Town of Hilton Head Island Regular Design Review Board Meeting

Tuesday, August 14, 2012
1:15 p.m. – Benjamin M. Racusin Council Chambers

Town of Hilton Head Island
Design Review Board
Minutes of the Tuesday, July 24, 2012 Meeting
1:15p.m – Benjamin M. Racusin Council Chambers

Paint color for Big Chill Ice Machine Awning

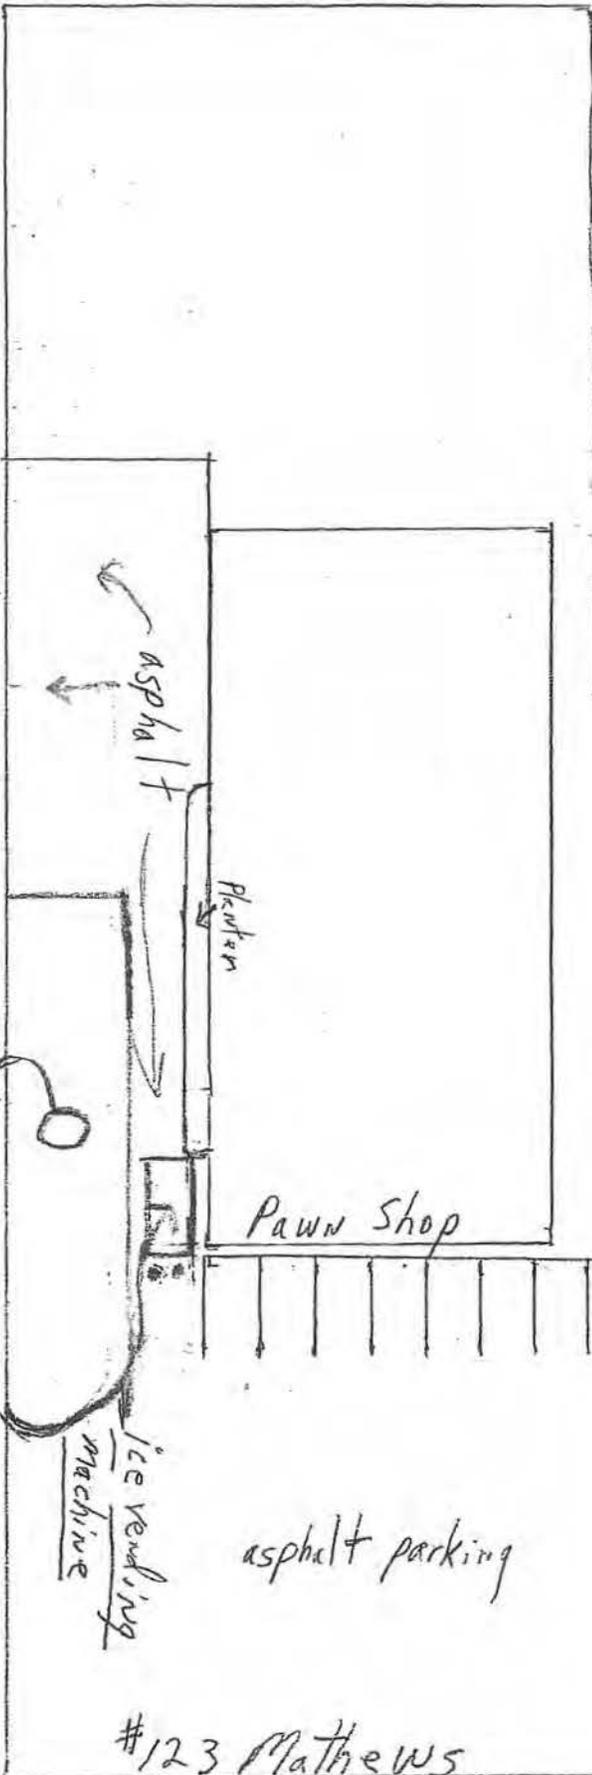
Applicants, Mr. Bubba Gillis and Mr. Patrick Mason, presented statements in support of the application. The applicants and the Board discussed the need to change the white color to match the color of the adjacent building. The Board recommended that the blue awning be changed to green. The machine should be screened from view.

The Board stated that they would like to see samples of the proposed colors and materials. The Board would like to see how the awning will look. A revised site plan will also be needed. After conferring with the staff, the applicant decided to **withdraw** today's submission for recommended changes. The applicant will resubmit his application at a later time.
